TECHNICAL SERVICE BULLETIN

Group:	0-GENERAL
Bulletin No:	SB-15-048
Issue Date:	4-11-2016
Vendor Ref.:	HMM-151208-J1

DPF SHIELD BRACKET CORROSION

SUBJECT VEHICLES: 12MY-16MY COE (Cab over Engine) Trucks (195, 195h)

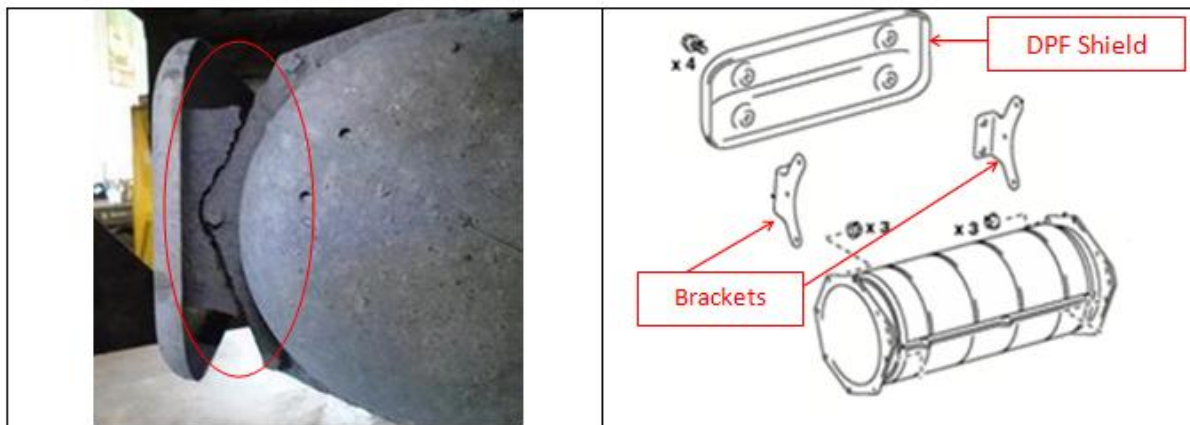
Subject vehicles may exhibit a broken DPF shield mounting bracket due to corrosion perforation. An enhanced DPF shield bracket made from stainless steel is now available to prevent this condition from recurring.

PART NUMBER	DESCRIPTION	QUANTITY
1754378020	DPF Shield Bracket	2
SZ10508083	Bracket Bolt	6 (As Required)
SZ17808015	Bracket Nut	6 (As Required)
9167180825	Shield Bolt	4 (As Required)
